Village of Bayside
9075 N Regent Road
Architectural Review Committee Meeting
June 5, 2023
Village Board Room 6:00pm

ARCHITECTURAL REVIEW COMMITTEE AGENDA

Attention:
Village of Bayside, WI
Architecture Review Committee

VILLAGE CODE REVIEW

PROJECT/SITE OWNER:	PROJECT SUMMARY:
Kathleen Roozen PROJECT ADDRESS: 9126 N Meadowlark Ln	New 6-foot wooden lattice fence approximately 259 feet open design.

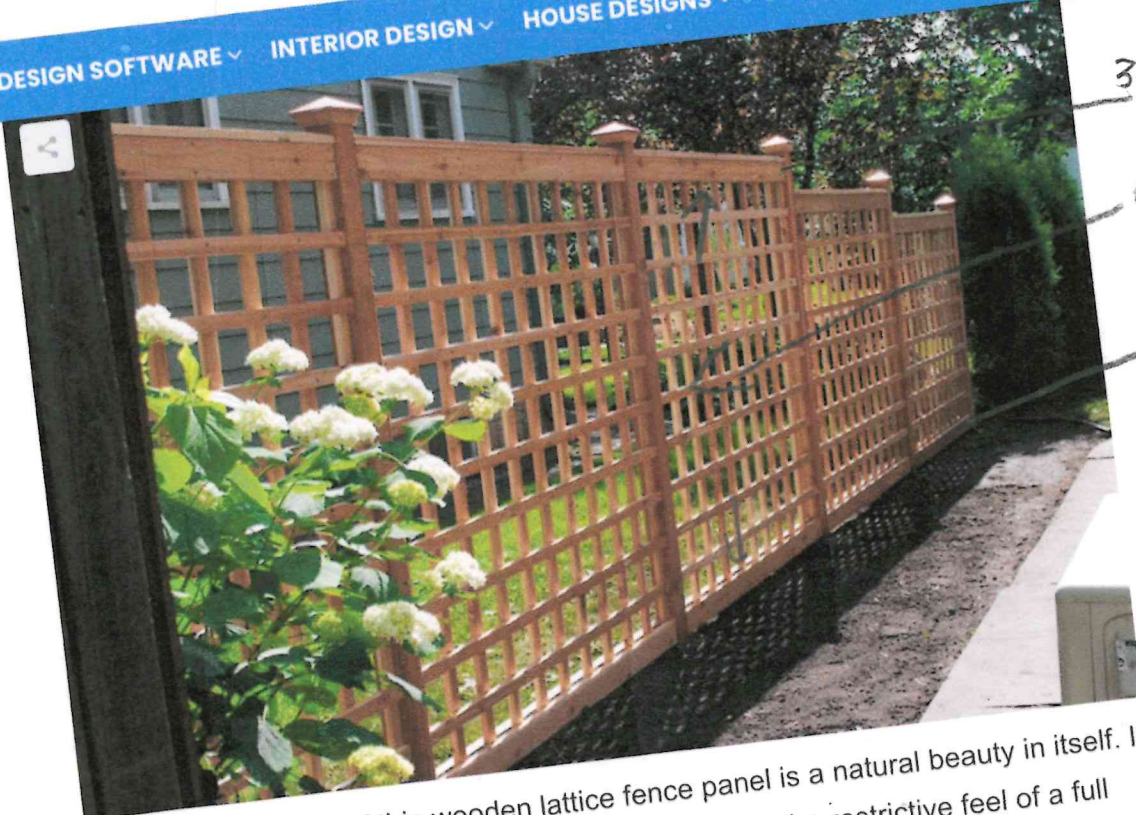
1. With the fence design being open lattice, this complies with the 50% open design requirement in the ordinance.
2. The board always considers matching fences with neighboring fences.

Recht Residence

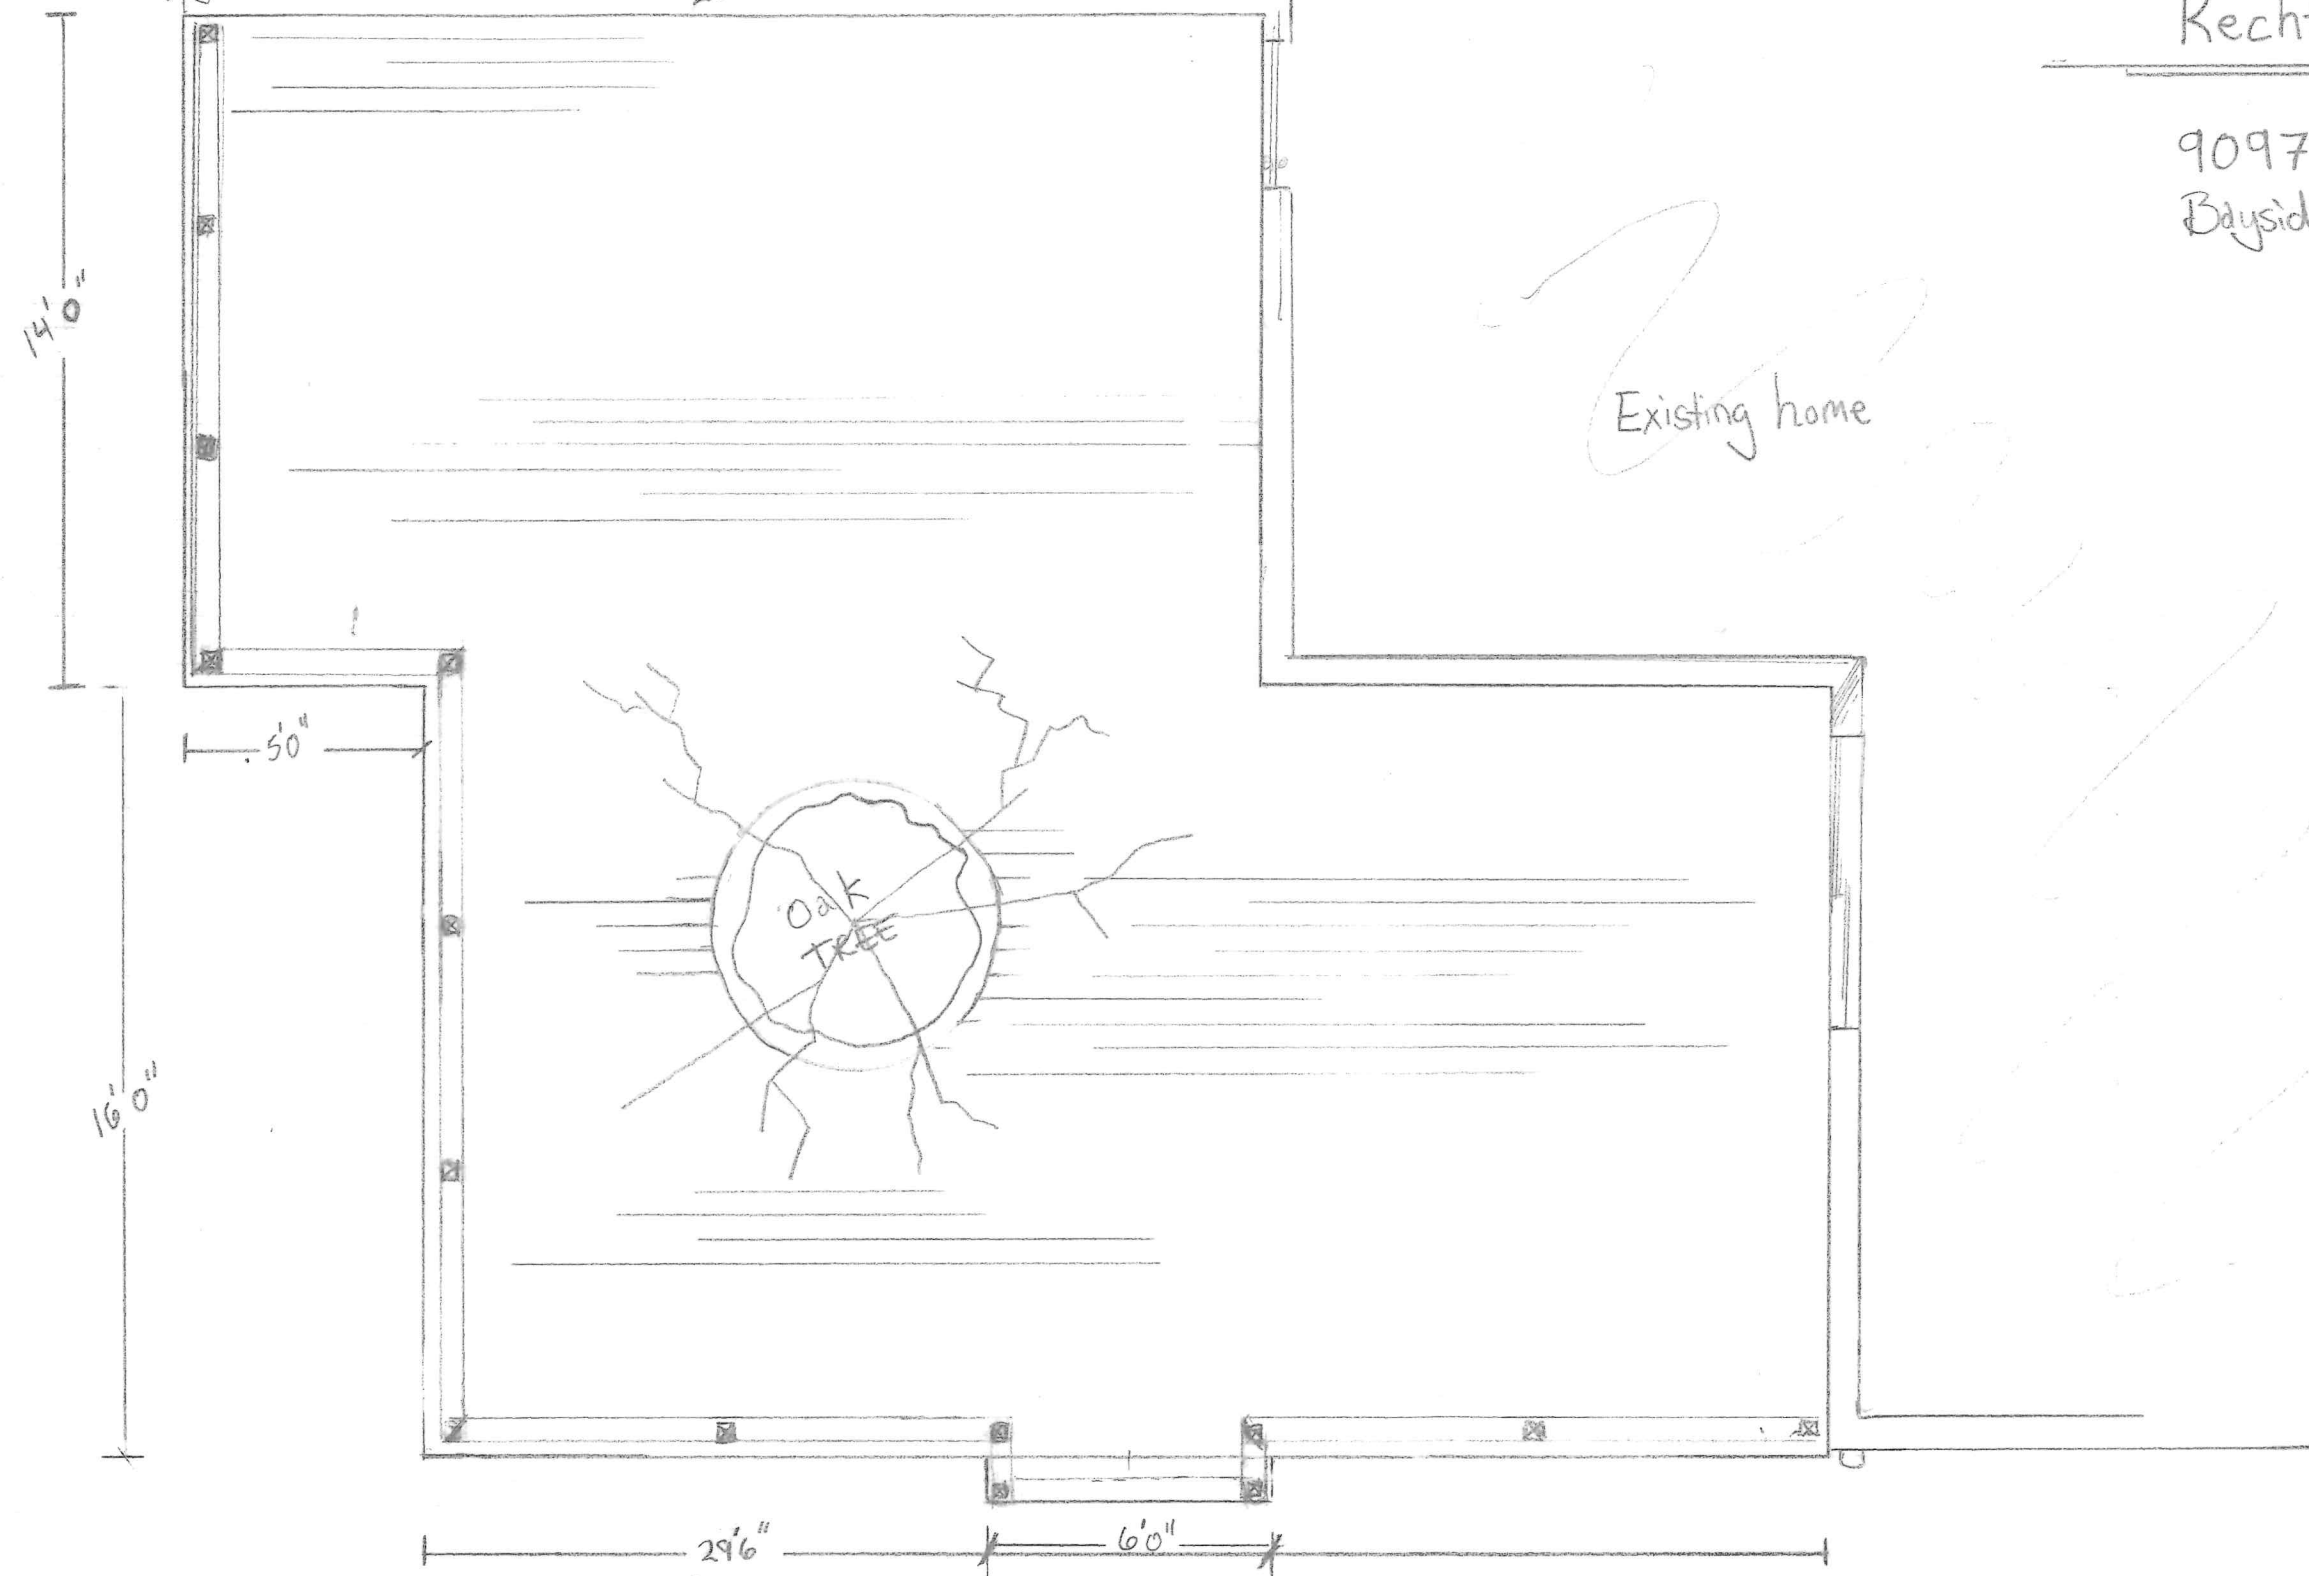
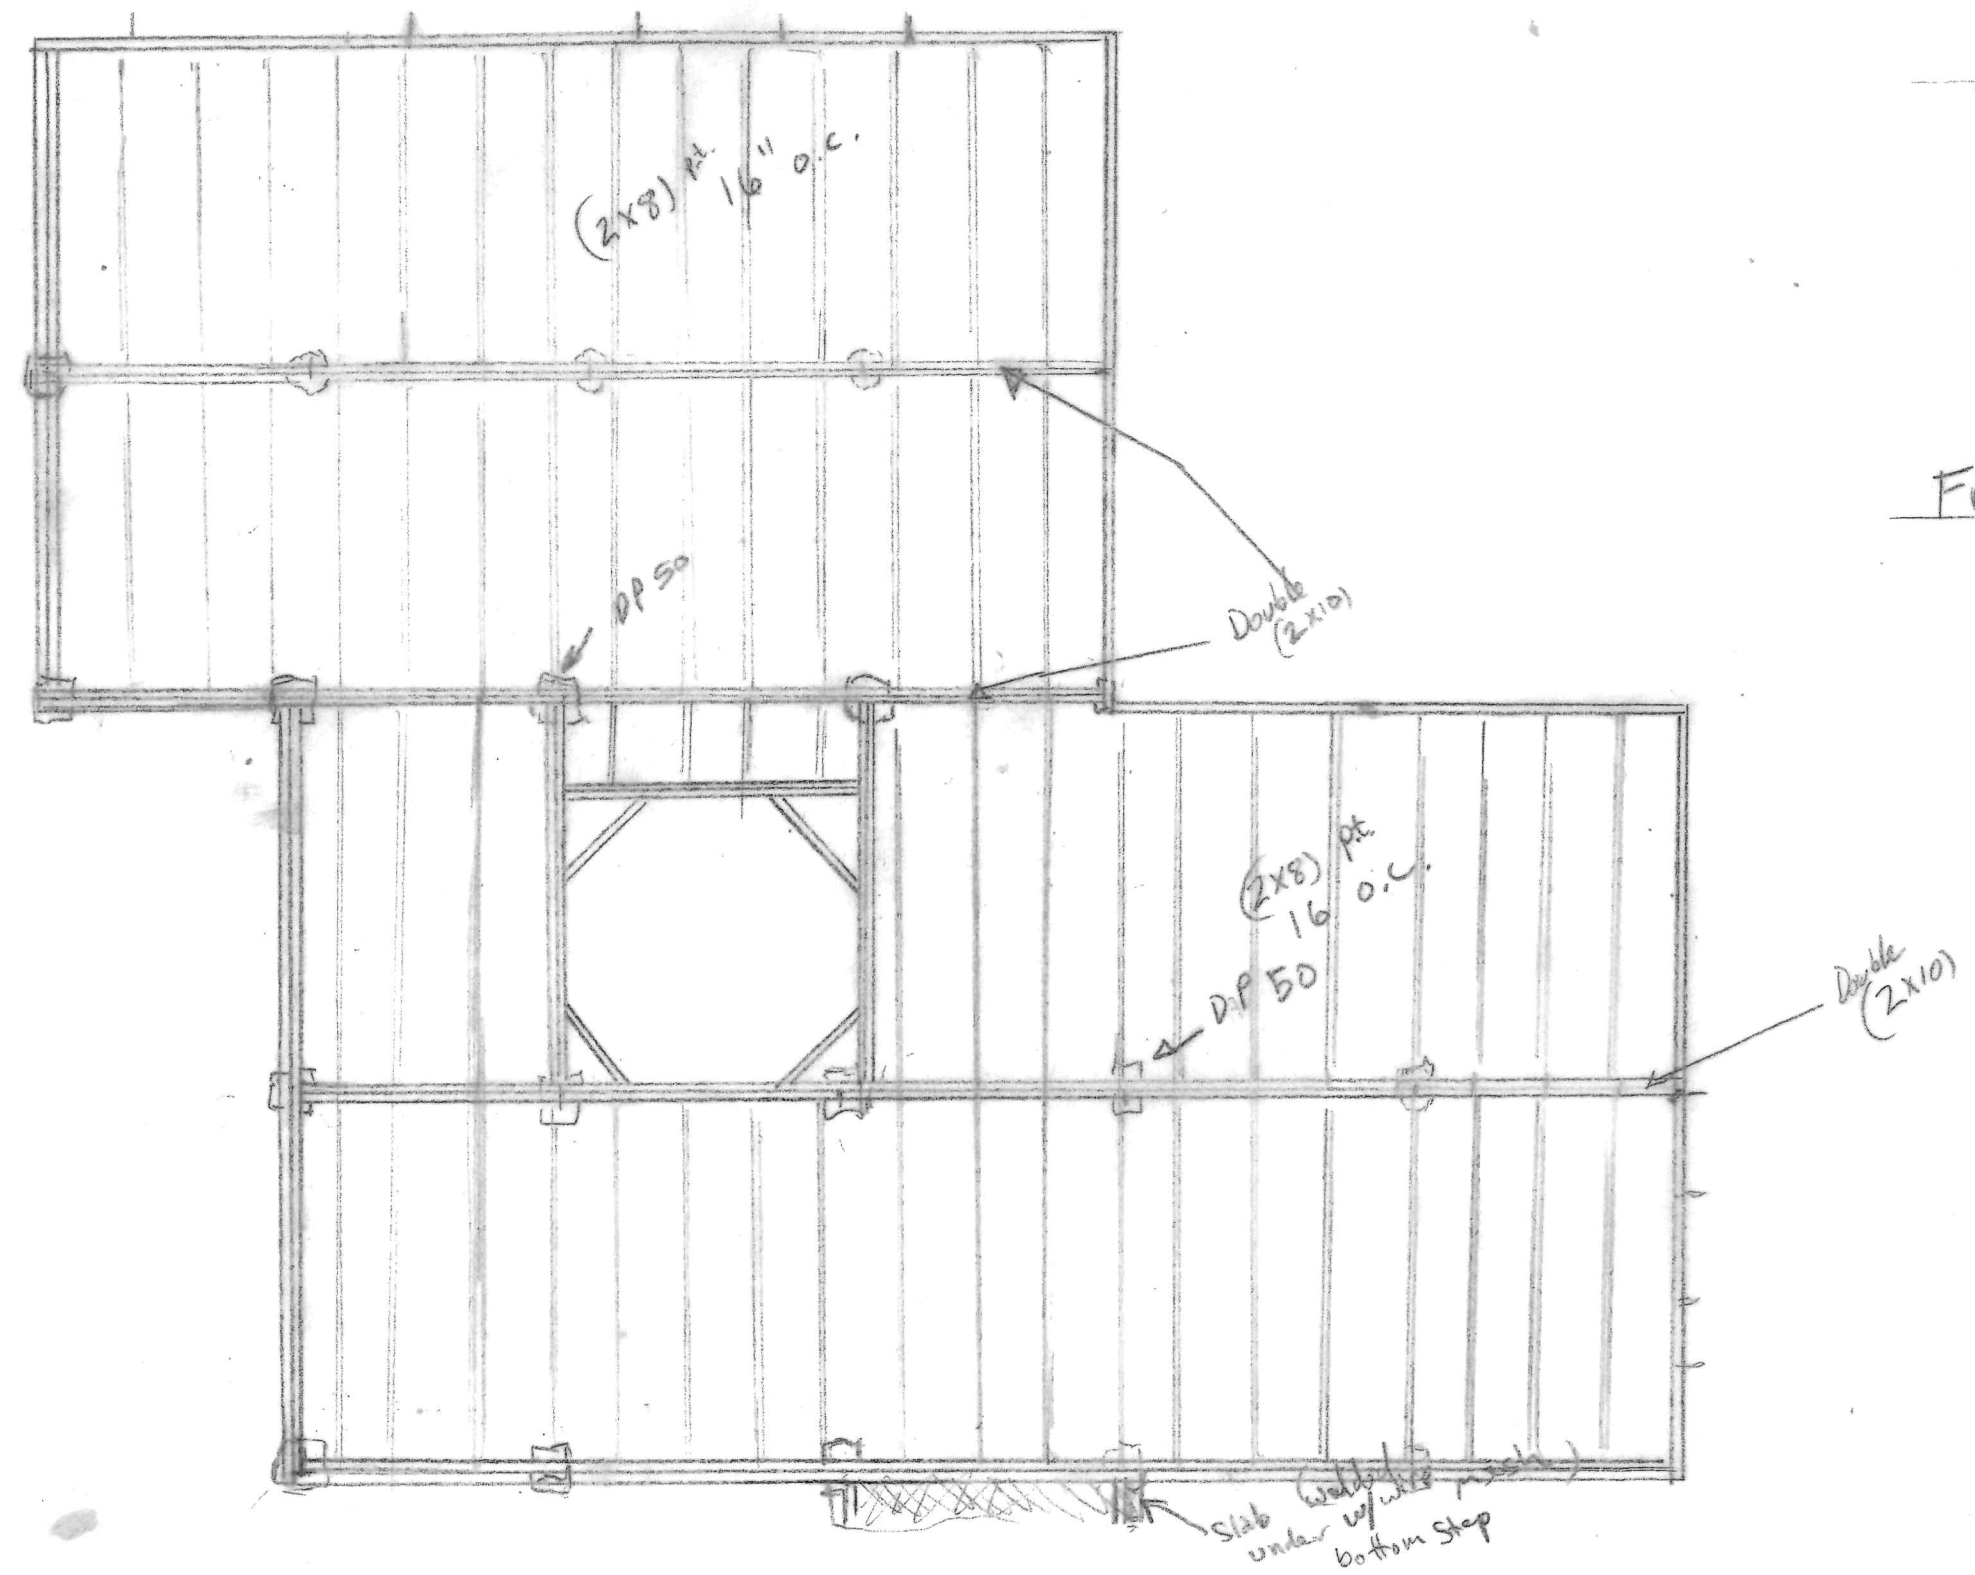
I have reviewed the proposed deck replacement and expanding of the foot print, for compliance with the Village's ordinances and have determined the following for consideration.

The deck is within the required set backs

There are no issues with this application.
